CS Memorandum No. 1343

Subject: Configuration Management Board Meeting No. 110

SUBJECT: Configuration Management Board Meeting # 110 – Rev. No. 0

Drawing Nos. ES-411(see attached mark-up)

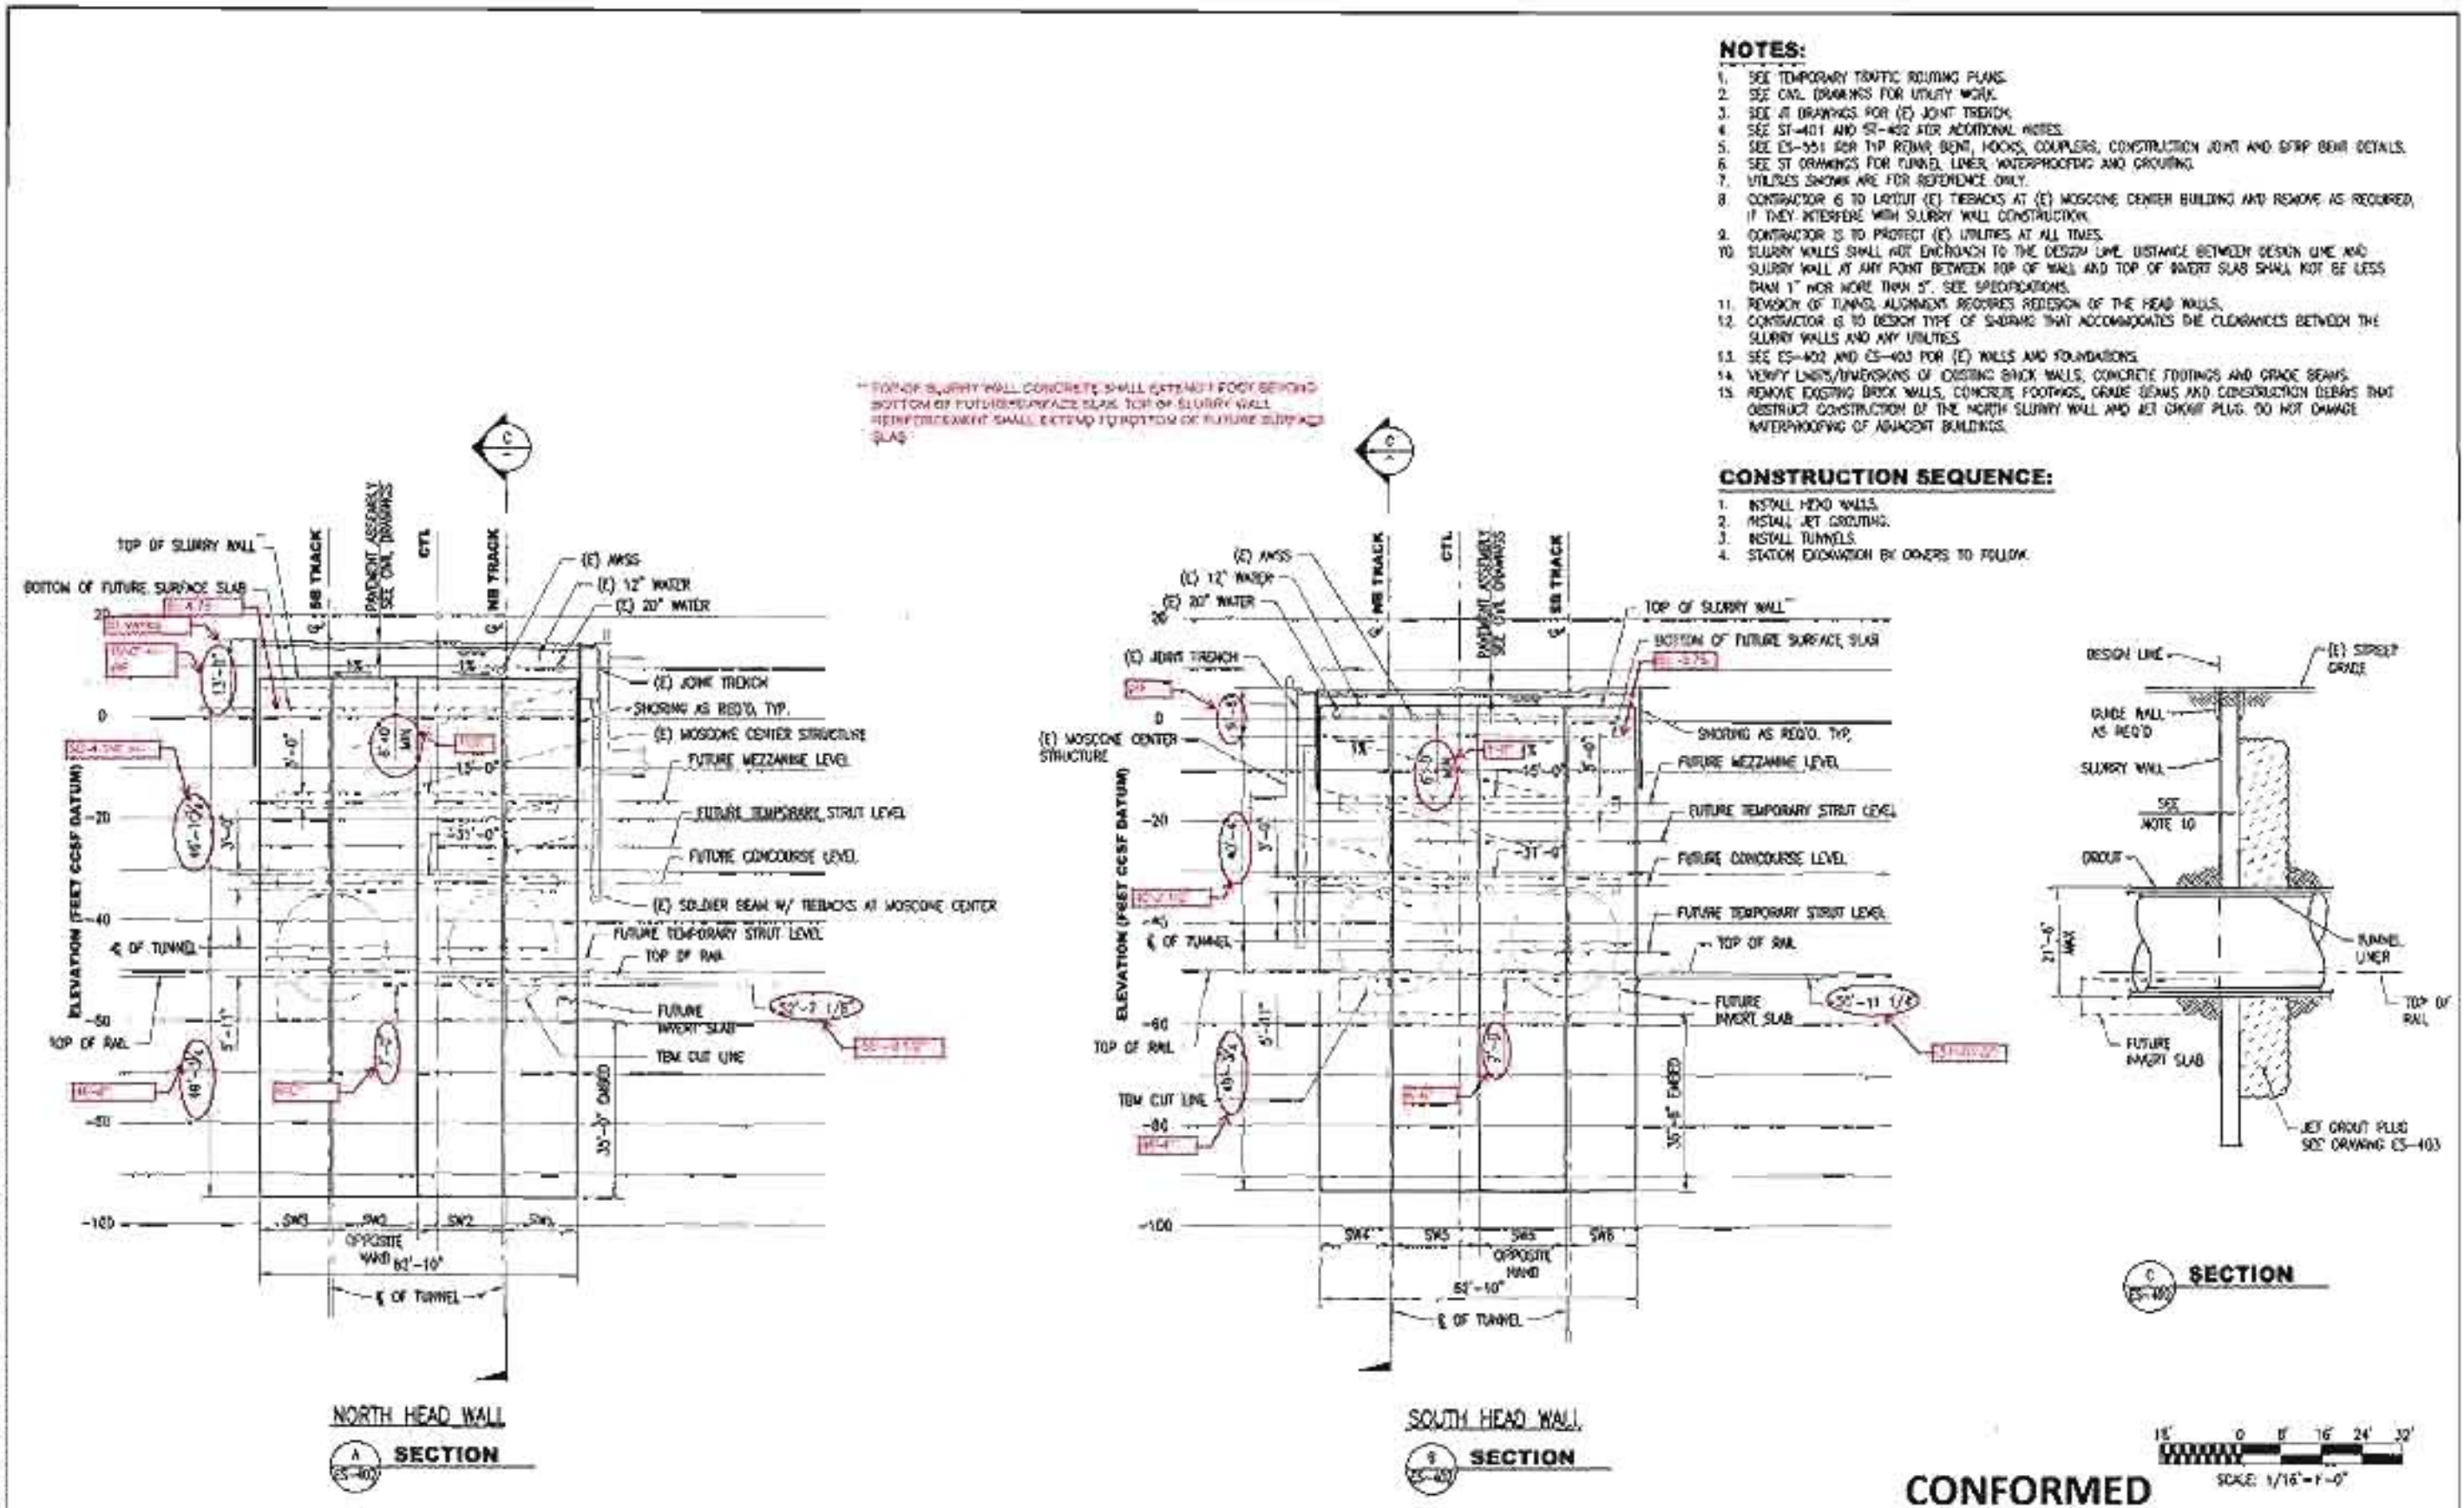
- Revise (raise) top of North Headwall elevation at MOS by approximately 3'-6"
- Bottom of future roof slab elevation is changed from El. 1.25' to El. 4.75'
- Slurry wall reinforcement shall extend to bottom of future roof slab
- Sound concrete shall extended 3'-6" above the bottom of the future roof slab

- Revise (raise) top of north headwall elevation at MOS by approximately 3'-6".
- Bottom of future roof slab Elevation is changed from El. 1.25' to El. 4.75'.
- Slurry wall reinforcement shall extend to bottom of future roof slab.
- Sound concrete shall extend a minimum of 1 foot above the bottom of the future roof slab.

Drawing Nos. Attachment 1
The Contractor's proposal in price and time is required on this proposed contract change to the subject contract in accordance with the General Provisions Section 6.02 B within 14 days after receipt of a PCC.

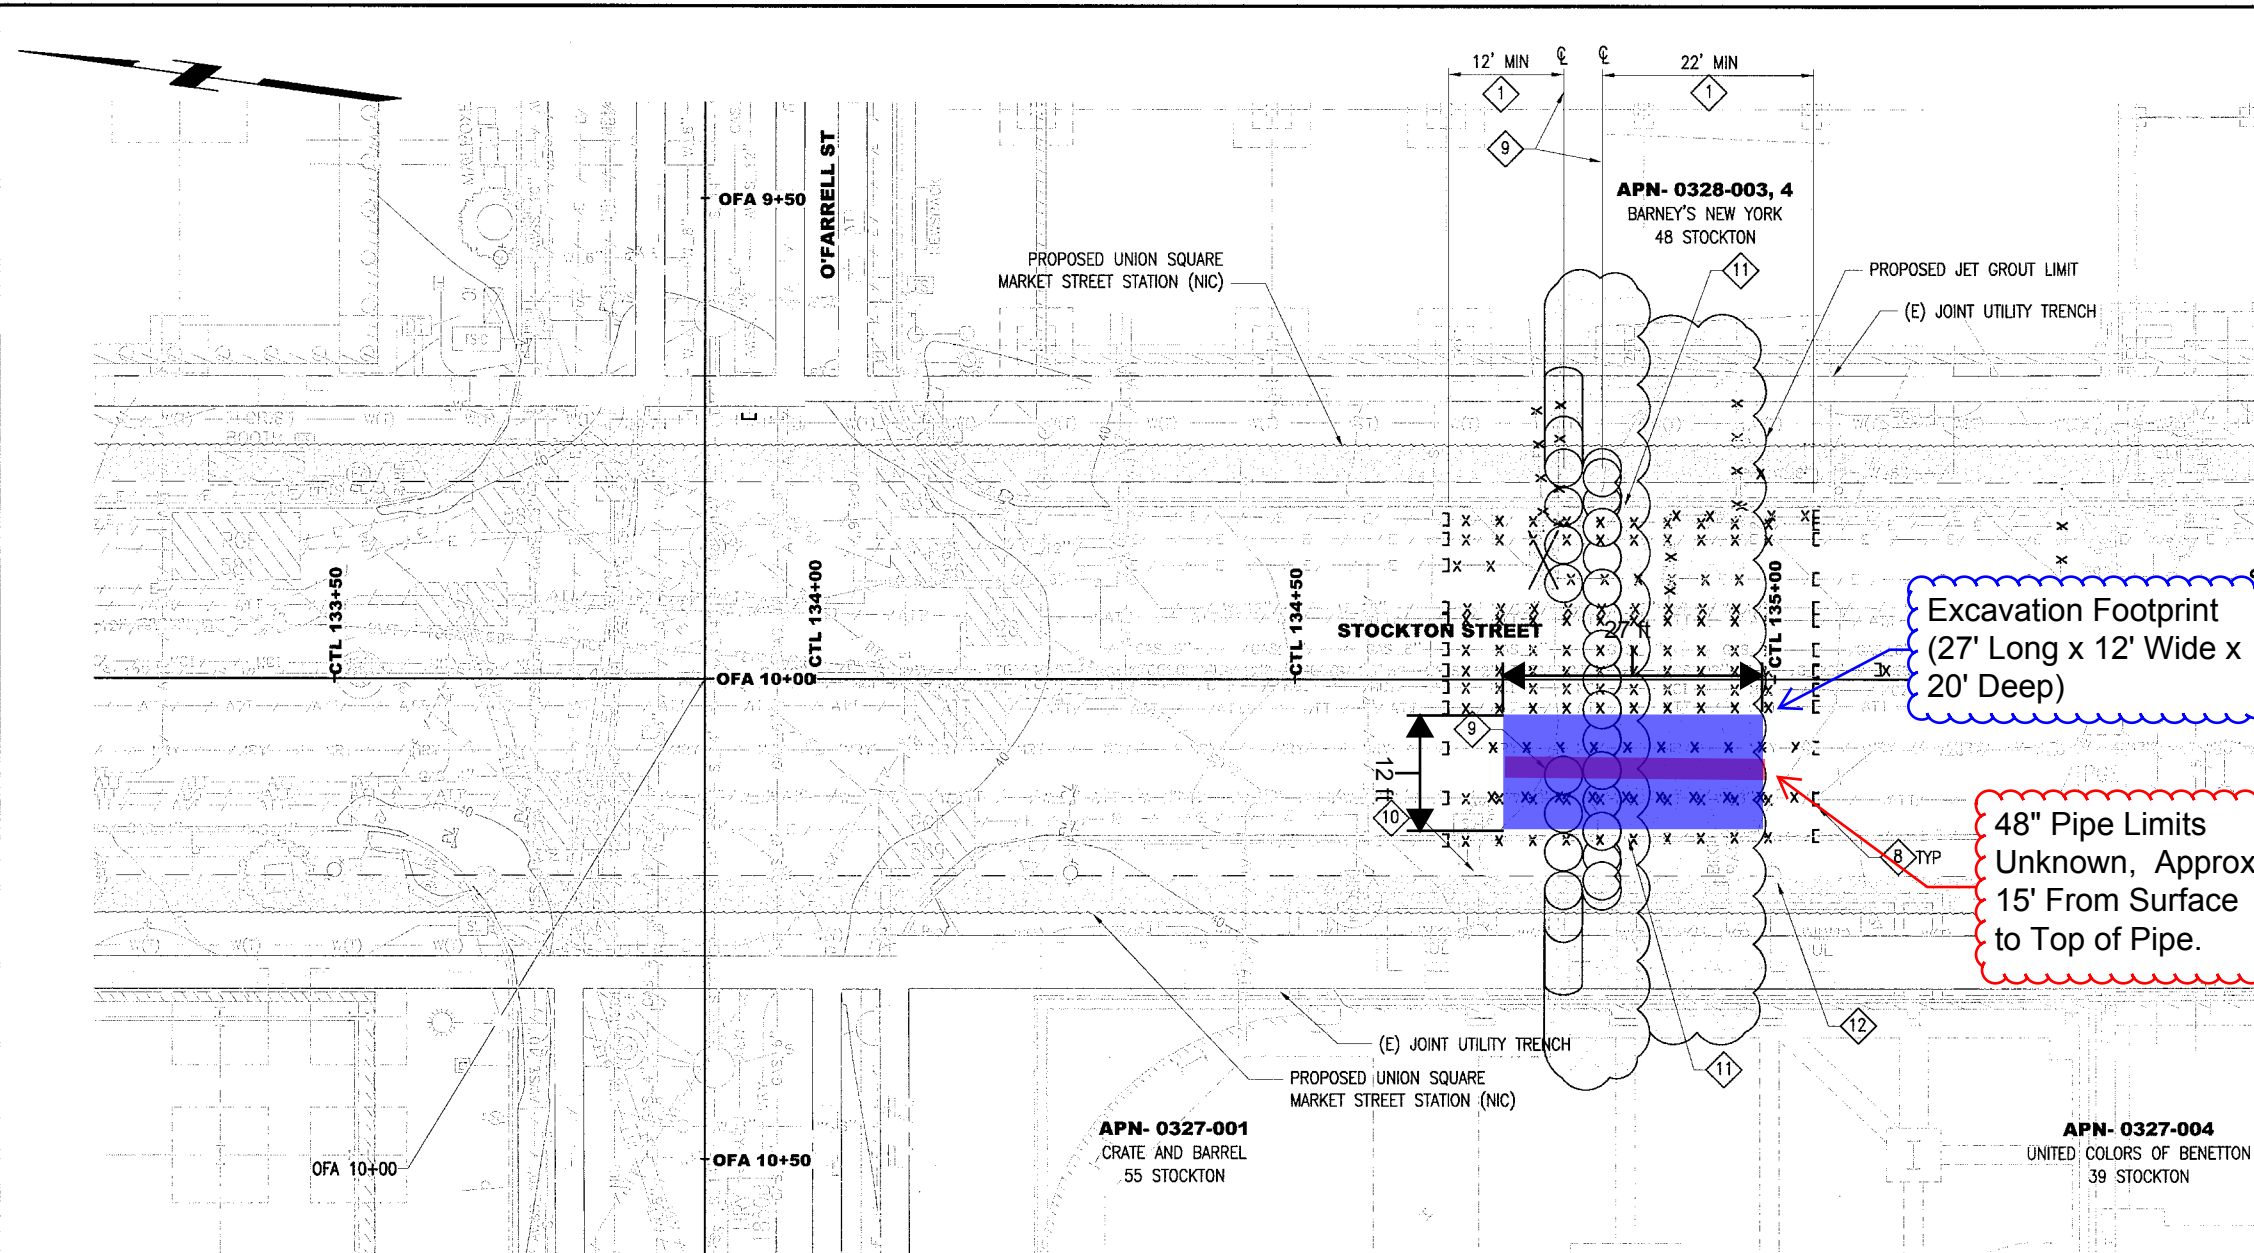
Description of PCC:	
<u>Summary of Changes:</u>	
<ul style="list-style-type: none"> Construct a shored excavation and expose pipe at the UMS south headwall. Footprint of excavation should be large enough to facilitate removal of pipe through limits of the headwall and jet grouting limits (see attached sketch for approximate footprint dimensions). Prior to execution of work provide support of excavation drawings stamped by a CA professional engineer. Attempt to identify limits of pipe through the use of a multi-signal transmitter and receiving equipment and/or ground penetrating radar. Drill hole into pipe via a "hot tap" method, which will utilize non-spark generating equipment through a pressure sealed valve welded to the side of the pipe. A work plan explaining the process is required to be submitted prior to performing the work. Perform video inspection of pipe (assuming that the pipe is not under pressure or full of fluid). Upon completion of small hole, a larger hole will be bored in the pipe, and a small camera can be inserted. Mini cameras (less than 2") are capable of videoing up to 100 LF in either direction, while larger cameras can video up to 2,000 LF.

What (Description of PCC) Investigate Unknown Buried Pipe.
Why (Reason for Requesting PCC) A. Unknown pipe discovered in the excavation of the south headwall at UMS is preventing Work to be completed in conformance with the contract documents. B. Unknown pipe has been determined to be a differing site condition in accordance with General Provision Section 3.04
Where (Location, Station) UMS South Headwall as shown on attachment 1.
When (Occurrence date, action date, potential time impact) November 8, 2012 unknown pipe discovered, November 15, initial investigation begins; potential delays to UMS headwall construction and follow on 1300 Contract Work.
How (Recommendation of Action) To be implemented immediately after end of 2012 Holiday Moritorium
Estimate (Summary of Engineer's Estimate w/EE attached) \$75,000
Spec Ref GP 3.04 and 6.05

S:\6n003\m544.1\FinalDesign\Drawing-821\2-Civil\Utility Demolition\Sheet Files CP03\M54423UD302.dwg FBayani Wed Jan 26, 2011 1:25 pm UD-302

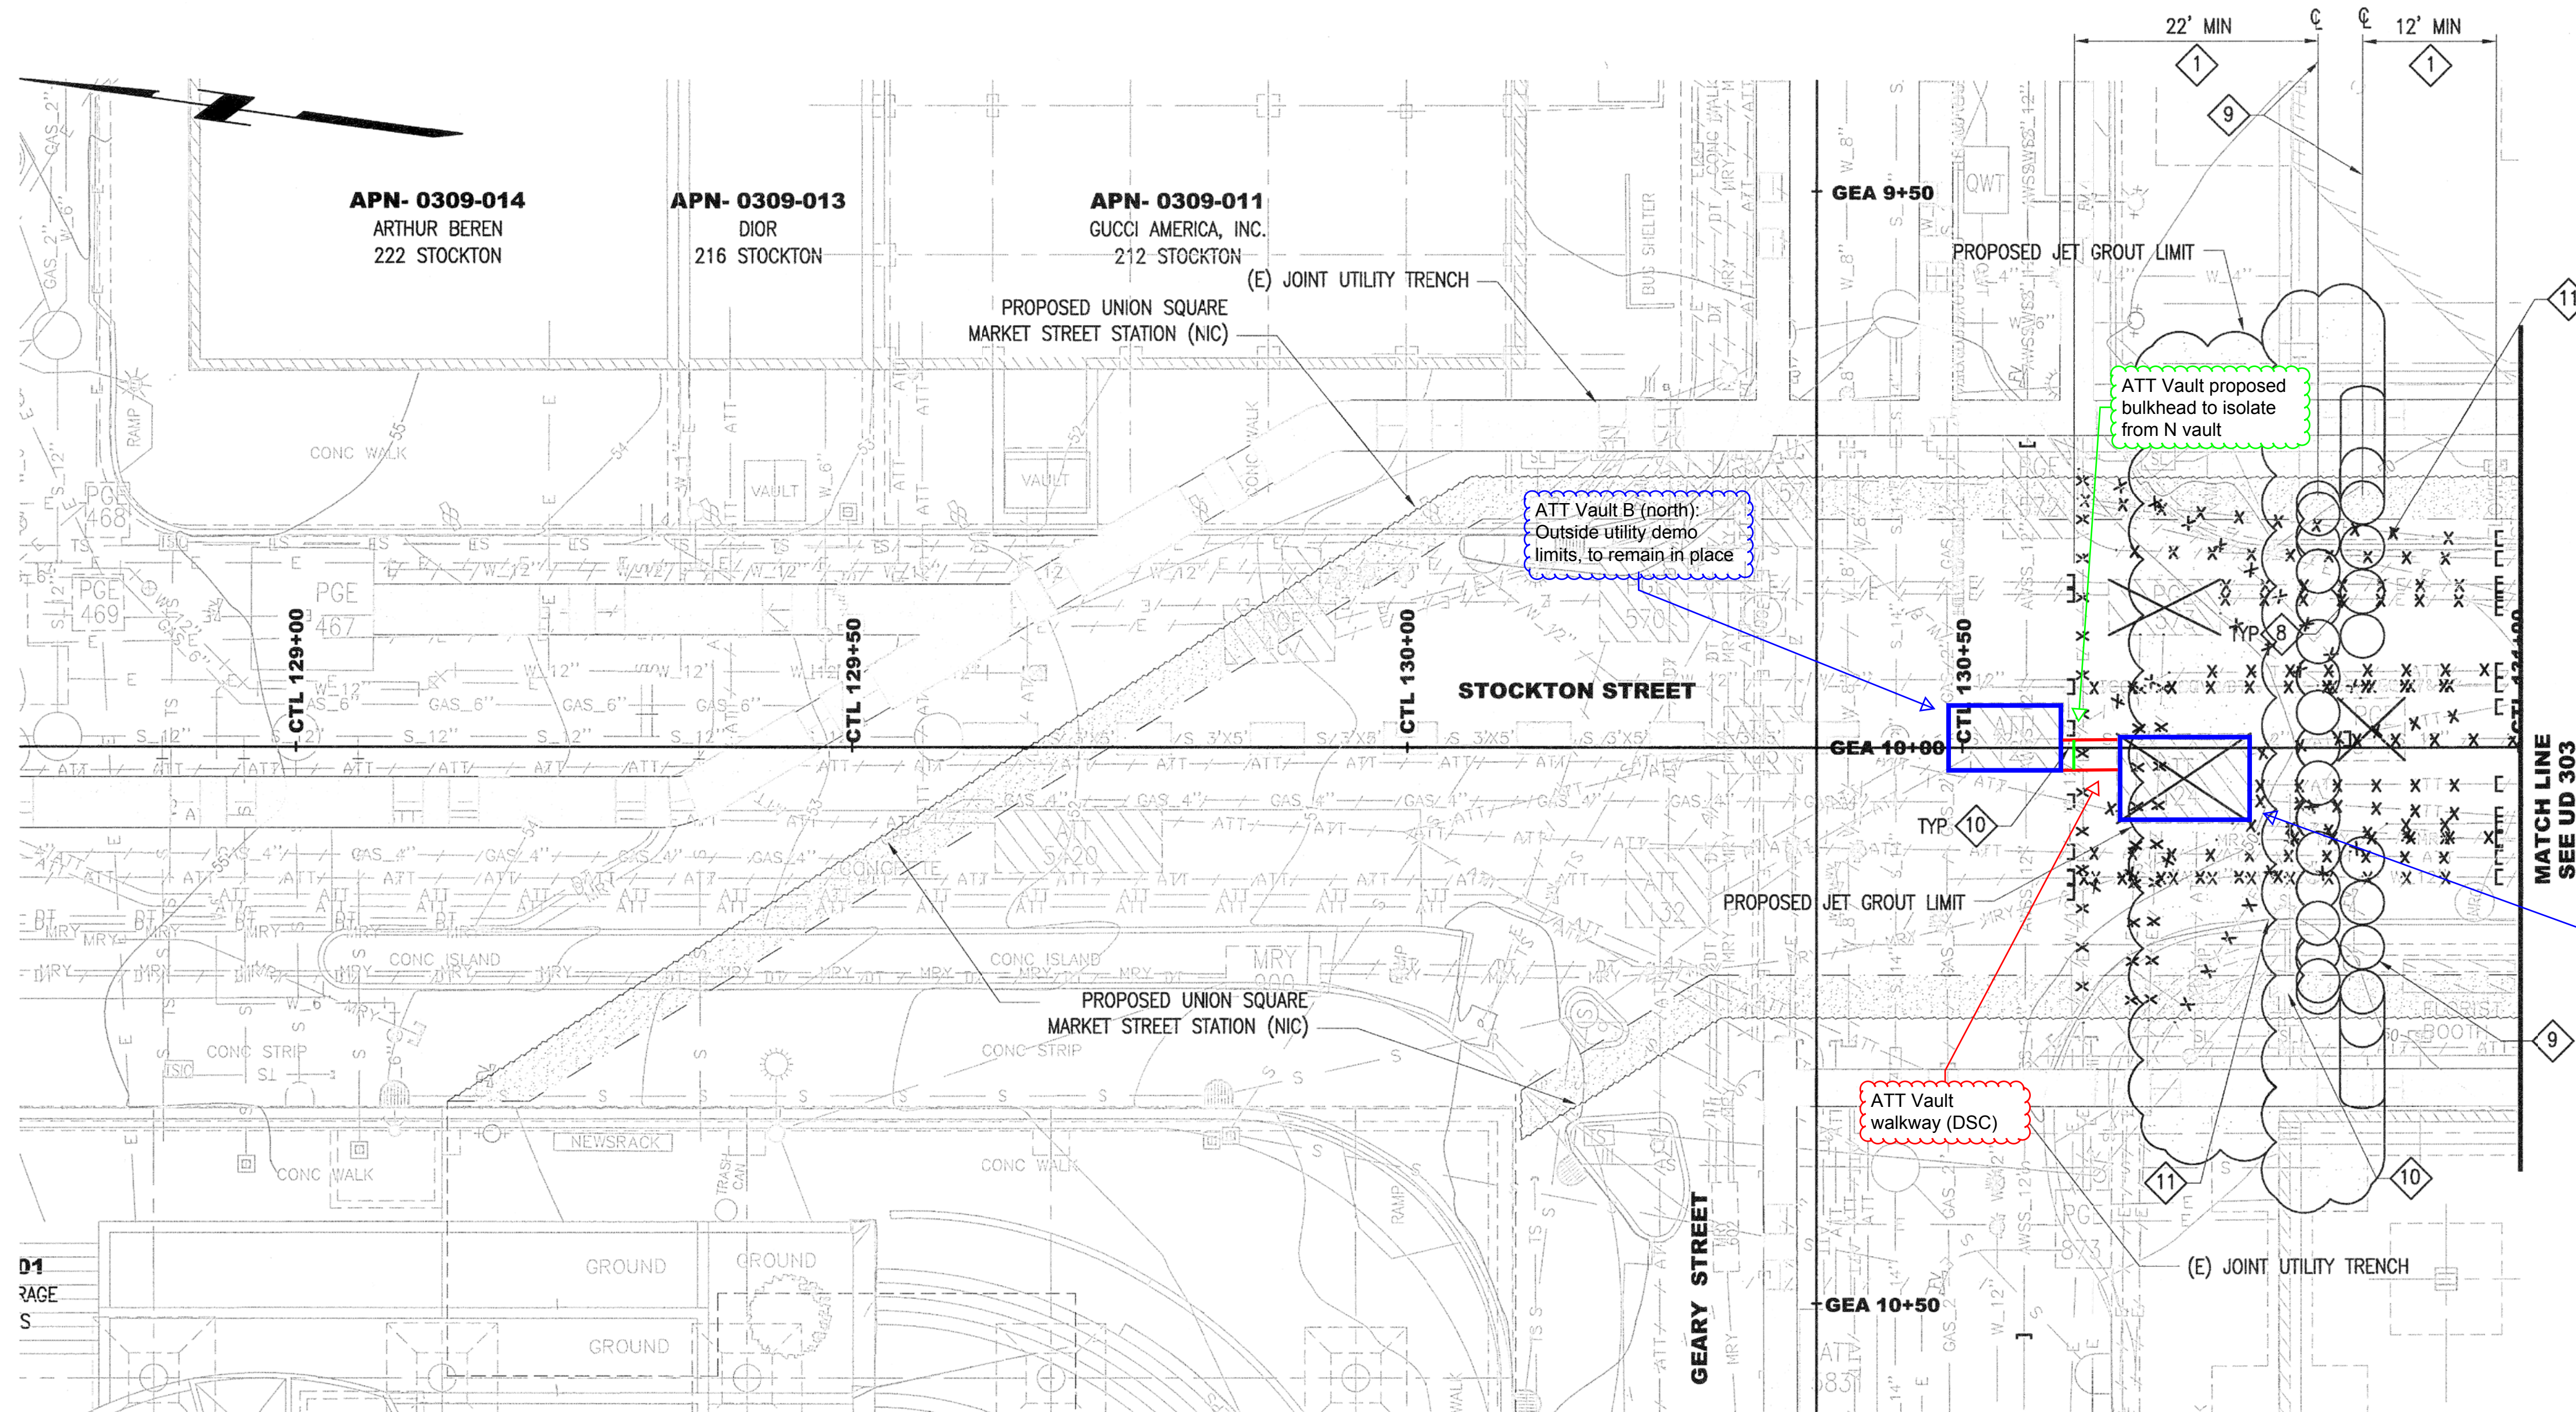
6-	1252 - Sarah Wilson presented Evaluation of Merit of COR 63 – 48 inch Pipe at UMS Headwall South - During excavation of UMS headwall south, the Contractor encountered a 48-inch pipe not shown on the contract drawing. The location of

ITEM #	DISCUSSION	ACTION BY DUE DATE
	the unforeseen pipe impacted construction of the head wall work. This discovery constitutes a differing site conditions. The RE evaluated the conditions outlined in spec sec. 3.04 Unforeseen or Differing Conditions. The CMB agreed with merit of the COR providing direction to the RE to issue a change order directing the Contractor to investigate the pipe and provide recommendation for removal or partial removal of the pipe.

Recommend we authorize BIH/SPM to proceed on Force Account with a NTE of \$2,000. STW; 1/16/13
